VLBA ACQUISITION MEMO # 311

HAYSTACK OBSERVATORY

To: Distribution
From: E. Nesmañ, V. Tran, K. Wilson
Subject: Recorder Controller Monitor Board Changes

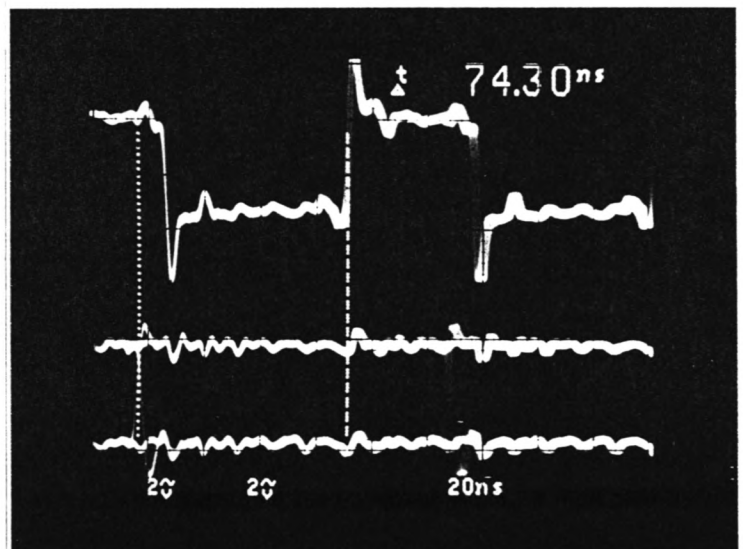
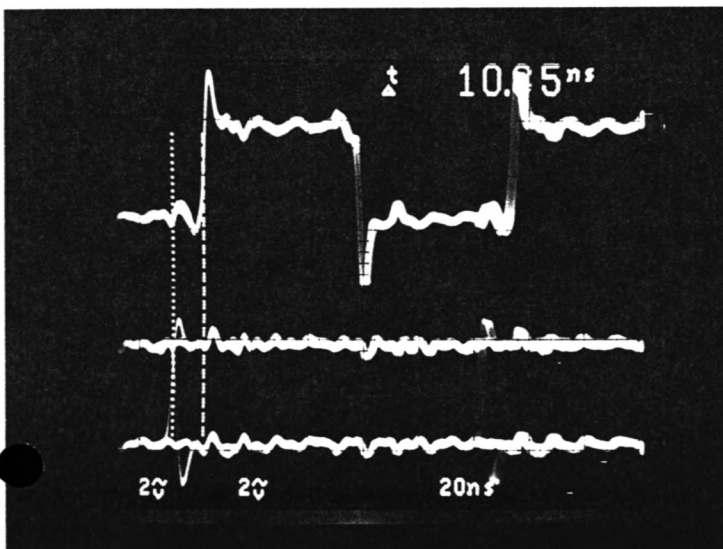
2. Data Extractor Malfunctions: The primary reason for the large number of faulty production boards was determined to be bad TI 74ALS86 IC's at location 5709. The bad IC's bear 1986 production date codes. This investigation also brought to light a marginal "data set-up time" situation at the NRZM decoder (74ALS175 at location 5720); this problem is corrected by inverting the clock as supplied to the clock distributor (74AS244 at location 6020). The inversion is implemented with a spare section of the 74ALS86 previously referenced. The set-up time is improved from a marginal 11 ns to about 74 ns. (See oscilloscope photos below.) Drawing C54328L006 has been revised to reflect this change and re-released as Rev. A.

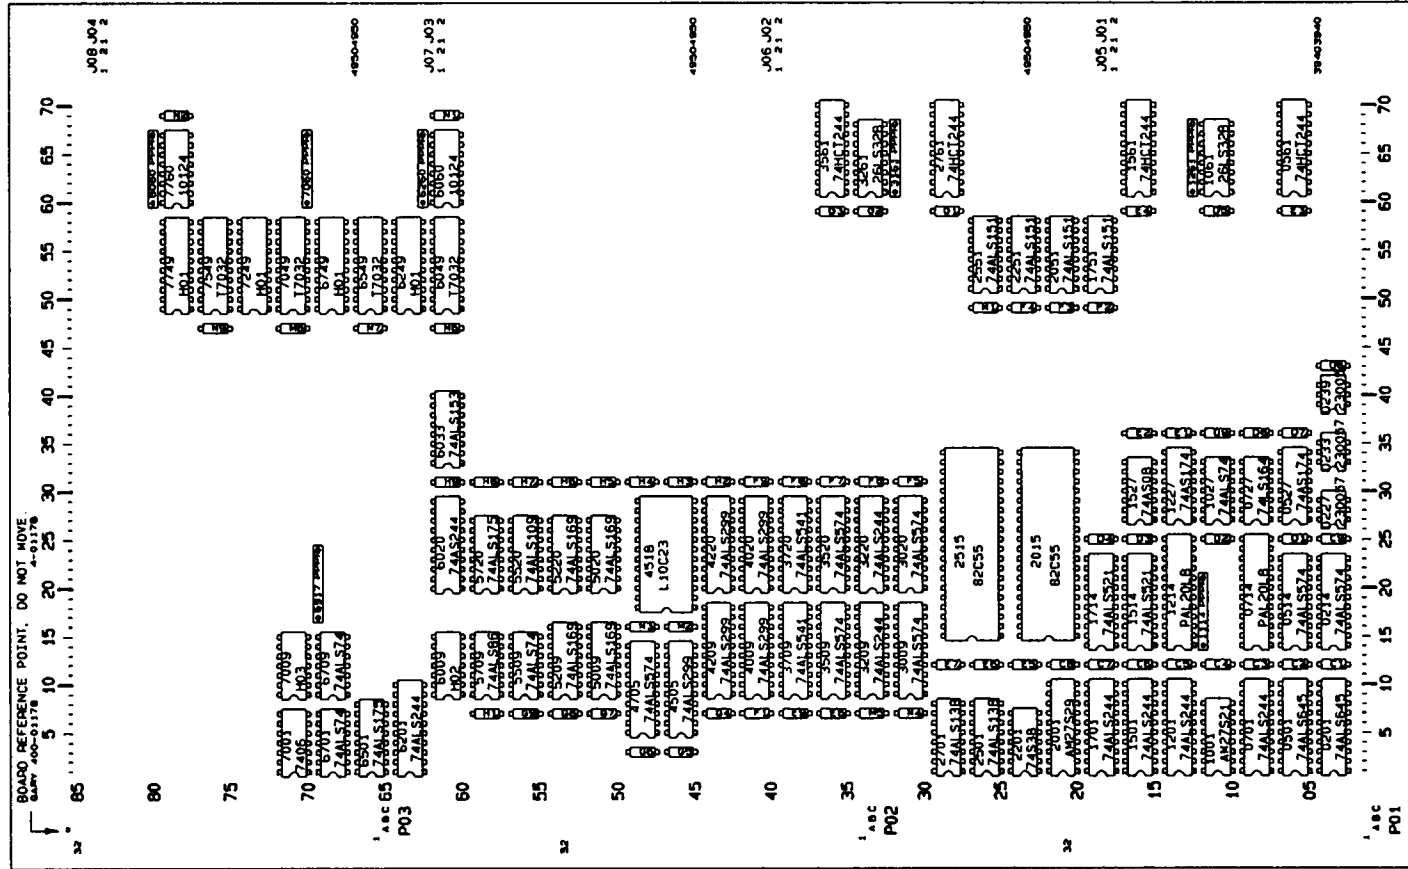
Timing diagram C54328V003 has been revised to reflect the use of the AT&T clock recovery IC and re-released as Rev. A. Also, assembly drawings C54328A001 and C54328A002 have been changed to show AT&T T7032 IC's instead of T7033 and re-released as Rev. A. Either type is acceptable in this application; however, the T7033 is no longer available. Block diagram C54328K001 has been revised to show the correct drawing number in the title block and re-released as Rev. A.

DES.	E. F. Nesman	26-OCT-90	MODULE	SIZE	DWG NO	REV
CHK.	E. F. Nesman	28-MAY-91	MONITOR	C	C5432BL004	A
APP.	A. E. E. Rogers	21-OCT-91	DATE	21-OCT-91	SHEET 04 OF 09

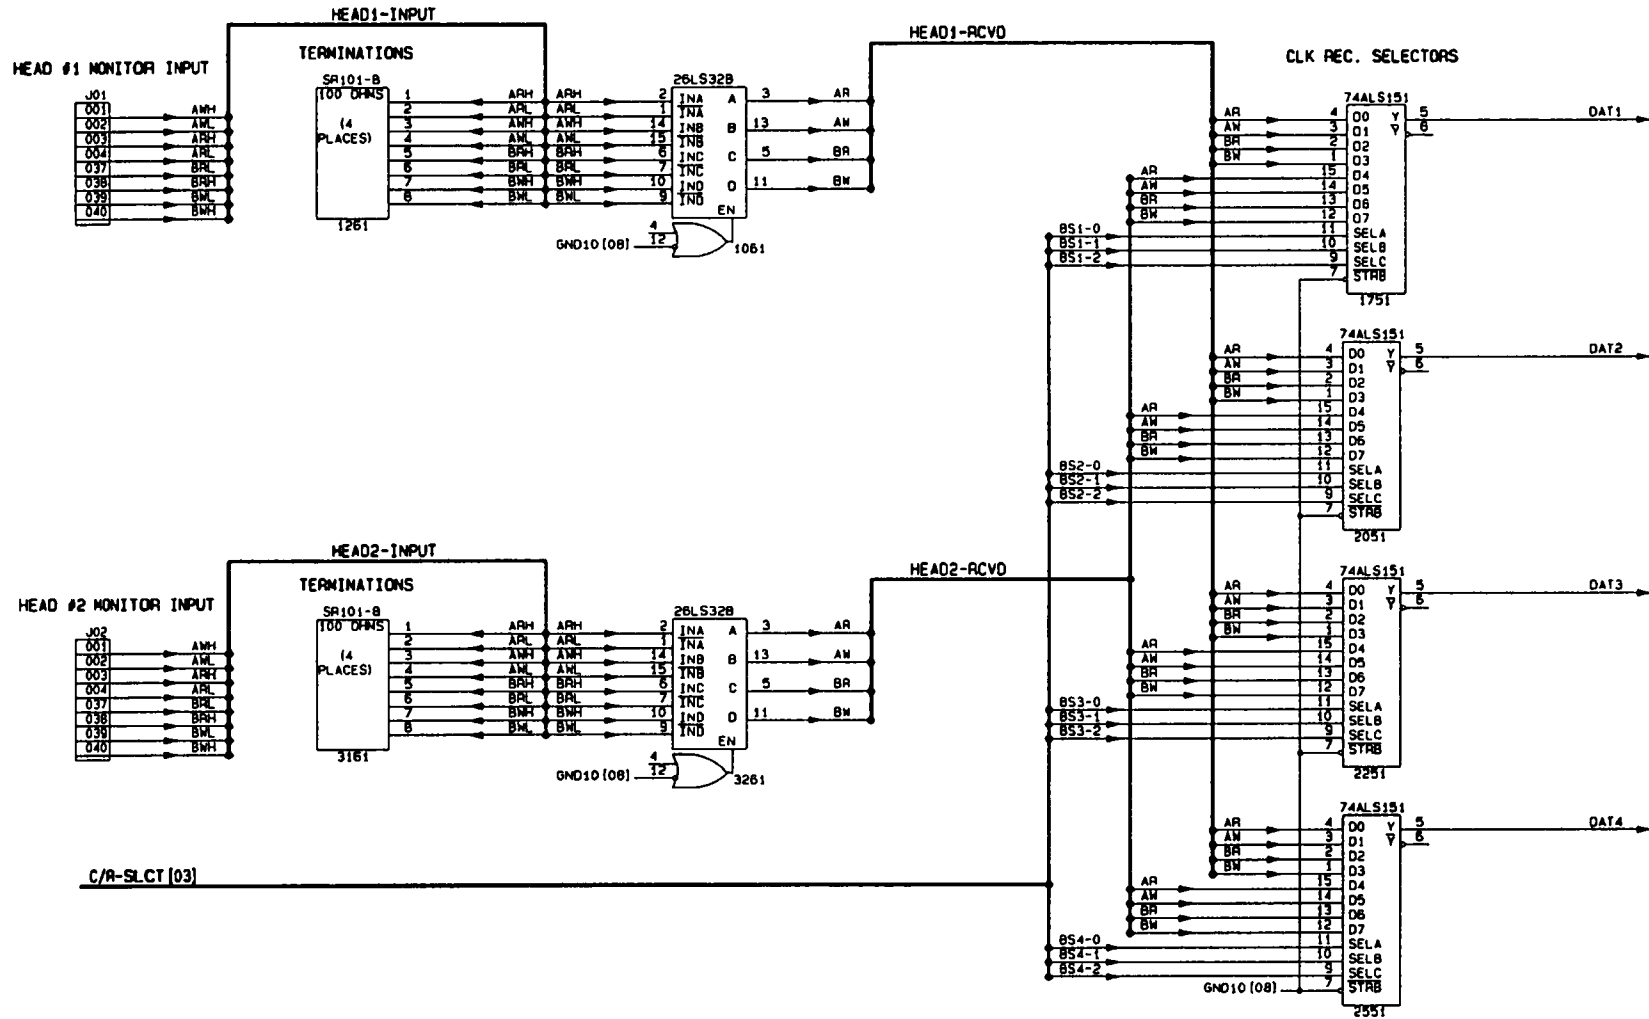
1. Monitor Input Terminations: A symbol pinout error exists on drawing C54328L004, wherein pins 2 And 3 are reversed on the SIP resistors at locations 1261 and 3161. This drawing has been corrected and re-released as Rev. A.

1. Monitor Input Terminations: This error can be corrected by performing the wire-wrap changes listed below.

From	To	Wrap Level
1163	1262	2
1061	1263	2
1263	J1-04	1
3463	3162	2
3261	3163	2
3163	J2-04	1

From	To	Wrap Level
J1-04	1262	1
1262	1061	2
1263	1163	2
J2-04	3162	1
3162	3261	2
3163	3463	2
